A Critique of the Dow Whitney Report

Que Hales, Doug Latta, and Kim Skinner
onBalance

Journal of the Swimming Pool and Spa Industry

Volume 4, Number 2, pages 29–41

Figures 1 and 2 – Diagram from Dow Whitney Report of Test Set-up and Photograph of Tucson Test Set-up

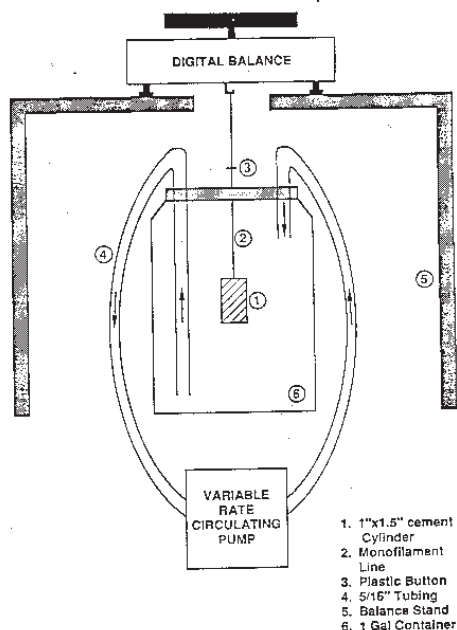
After drying, each of the ten 0.4 w/c samples were suspended in a 10 gallon aquarium filled with 10 gallons of distilled water, and were left to equilibrate for four days (see Figures 1 and 2 for illustrations of the set-ups). The same process was followed with the 0.45 w/c and 0.5 w/c coupons. (The same procedure was also followed with the aggre-

- Did the Dow Whitney experimenters use aggregate in the coupons? It doesn't seem as though they did, which is curious in light of the efforts to make other parameters as “pool-realistic” as possible.
 - Also in this vein, what determinations were
- The Journal of the Swimming Pool and Spa Industry

made to suggest that formed plaster surfaces react in a significantly similar manner as trowelled surfaces? This especially in light of the report's documentation of the changing amount of calcium hydroxide at surface as a result of multiple trowel passes?

Figure 3 – One of the 0.45 Cement:Water Ratio Coupons from Tucson Test Set-up (Before Six-month submersion)

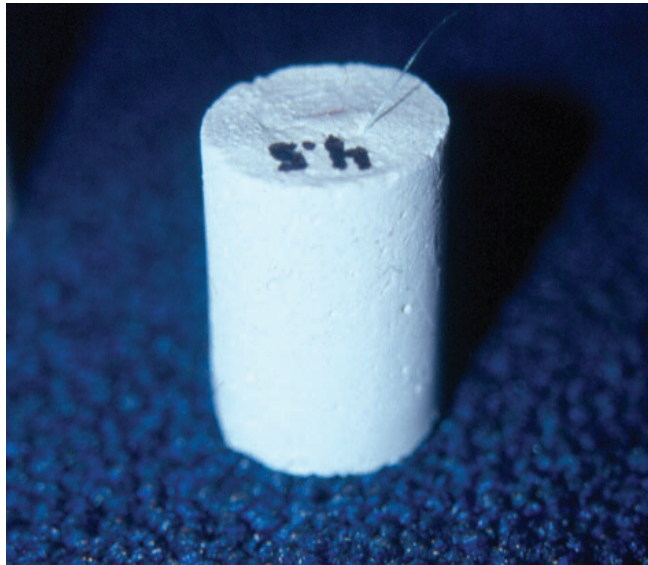
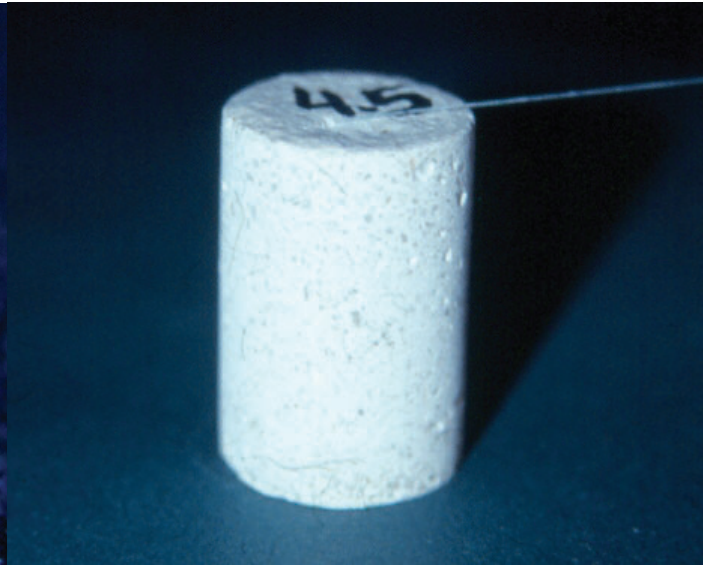
Over the course of the six months, the coupons each either maintained weight (to the hundredth of a gram) or very slightly increased or decreased in weight (in the range of 0.01 to 0.02 grams). The starting and ending weights are given in Table 1 (for aggregate coupons) and Table 2 (for paste only coupons). The coupons also lost a slight amount of surface, as evidenced by the a translucent appearance on the 0.5 w/c coupons and a clear view of aggregate on the 0.4 w/c coupons (see Figures 3 and 4). There also developed, over the first weeks of the experiment, a film of white powder, assumed to be calcium-based, on the bottom of the aquariums. After six months, when this powder was dissolved and the aquarium water was analyzed, it was found that the calcium level of the water in the aggregate aquariums averaged approximately 300 ppm, and the paste aquariums averaged 220 ppm, as ascertained by an EDTA titration expressing results as CaCO_3 (see Table 3). It can be determined by calculation that if all of the calcium in the sample were CaCO_3 , the weight loss of calcium per coupon would be approximately 1.04 and 0.83 grams respectively. Since the coupons actually maintained, and in some cases even slightly gained weight, it may be that the weight of water incorporated into the cementitious compounds formed exceeds the weight of the calcium lost. However, since this experiment has not been repeated, more experimentation will be needed to see if this result is consistent.

- When we performed this experiment (with aggregate-containing or aggregate free coupons), why do the coupons always etch evenly over the entire coupon, and never in a spot pattern?

In verbal conversation, Dr. Whitney claimed that, when performing this experiment, the coupons always “spot etched”. However, in the report itself, no physical description or photographs of the coupons were given, no weight loss was documented, and no specific statement was given that the coupons either etched (although we suspect they did) or that they spot etched (which we suspect they did not).
